Hydrazine Blending and Storage Facility  
Interim Response Action

Final Implementation Document for Decommissioning  
(Phase I)

Re: Rocky Mountain Arsenal (RMA)  
Hydrazine Blending and Storage  
Facility Interim Response Action  
Draft Final Implementation  
Document for Decommissioning  
(Phase I), January 7, 1991.

RESPONSES TO EPA COMMENTS REGARDING THE HYDRAZINE BLENDING AND  
STORAGE FACILITY INTERIM RESPONSE ACTION DRAFT FINAL IMPLEMENTATION  
DOCUMENT FOR DECOMMISSIONING (PHASE I)

Figure 3.1  
DECOMMISSIONING SCHEDULE -- IRA H PHASE I

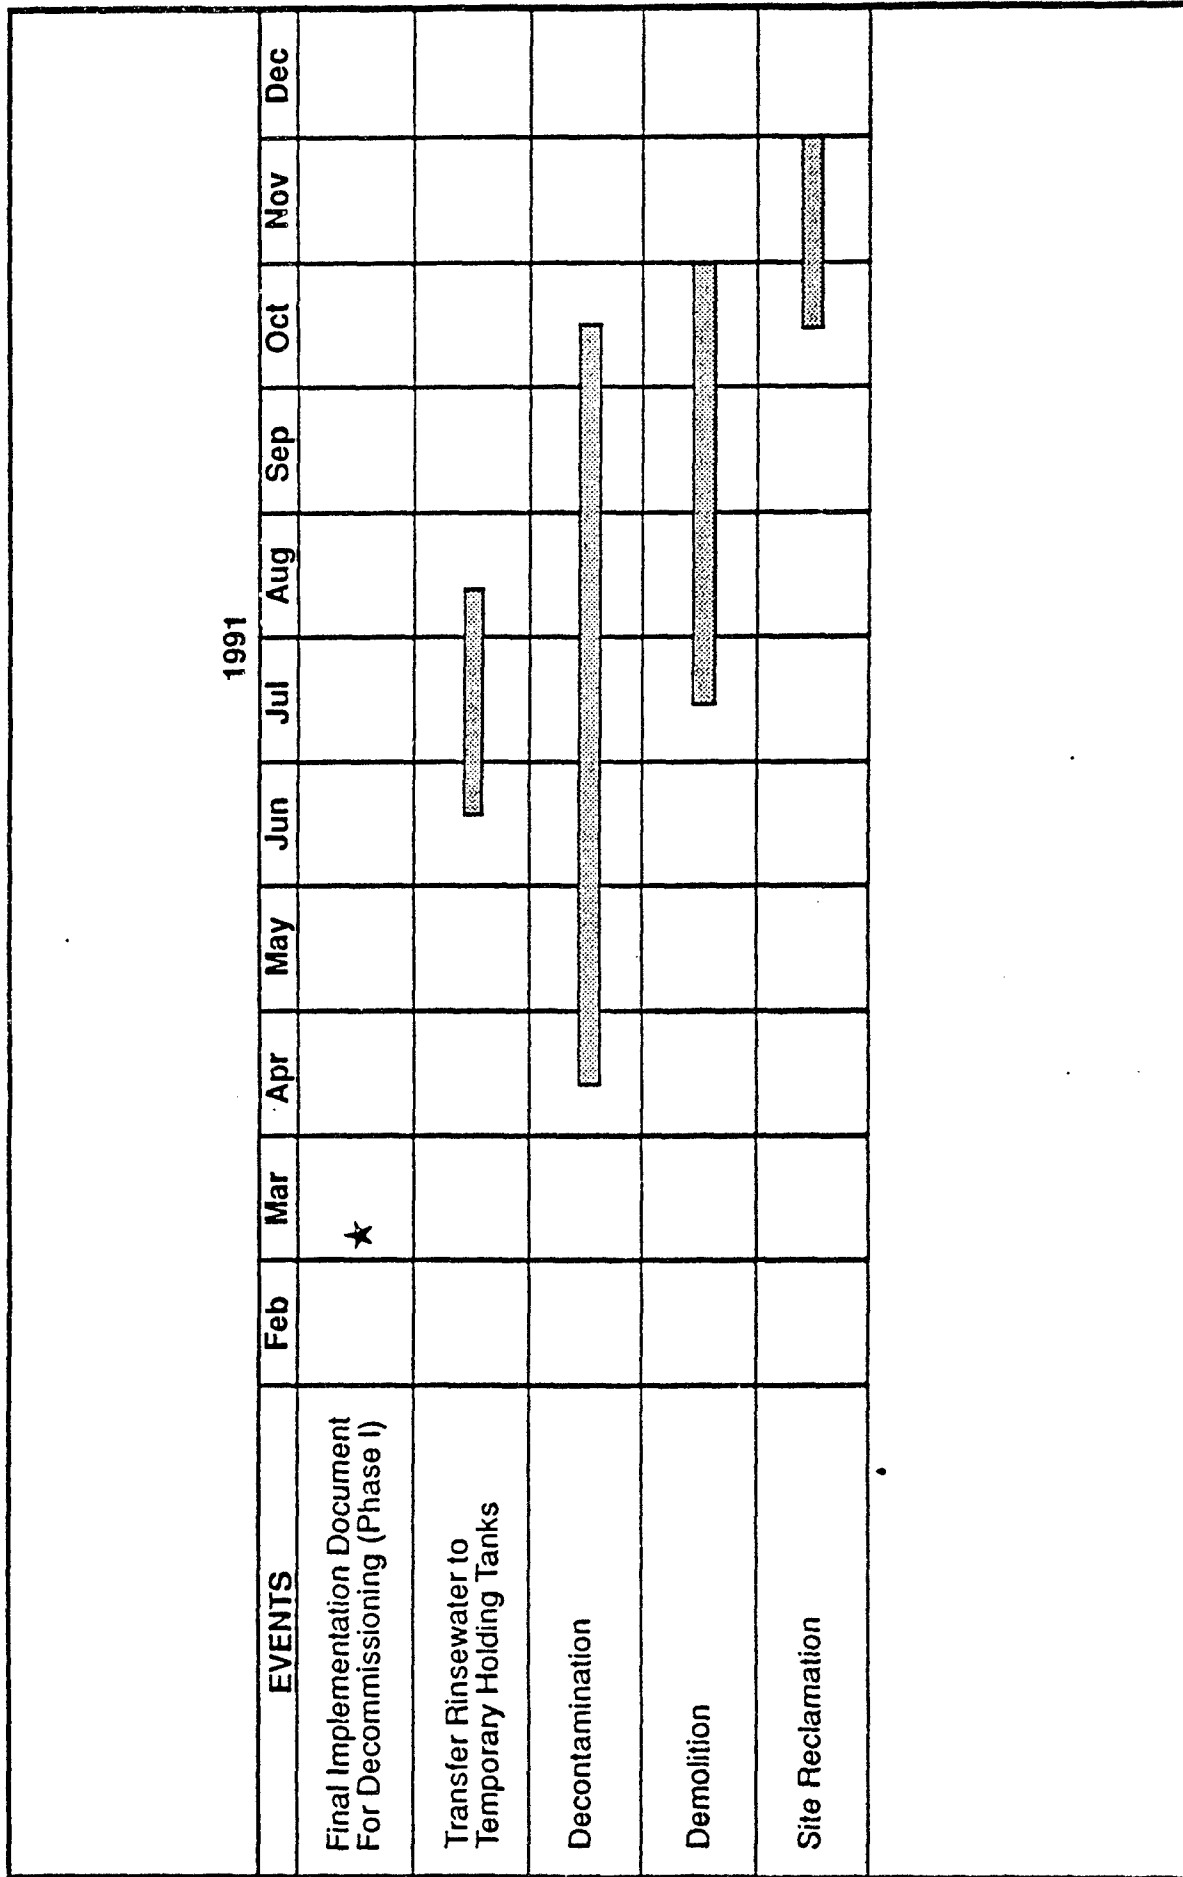
*Figure 3.1: The schedule reflected in this figure indicates that the Army intends to transfer wastewater to temporary holding tanks by mid-March. This is totally inconsistent with representations made at recent hydrazine wastewater IRA meetings. At those meetings parties were informed that decisions regarding disposition of the wastewater would have to be made immediately to enable the Army contractors to dismantle Tanks US 3 & 4 and the sump by August 1991. This inconsistency must be clarified.*

*The schedule presented in this document also contradicts that set forth in the Army's primavera planning document which states that decommissioning of the HBSF is anticipated to be completed no earlier than August of 1992. In view of this schedule, it is difficult to understand the urgency recently communicated by the Army regarding this IRA.*

The schedule in Figure 3.1 has been corrected to show a mid-Summer 1991 transfer of the rinsewater and late Summer dismantling of tanks US-3 and US-4 and the in-ground concrete sump.
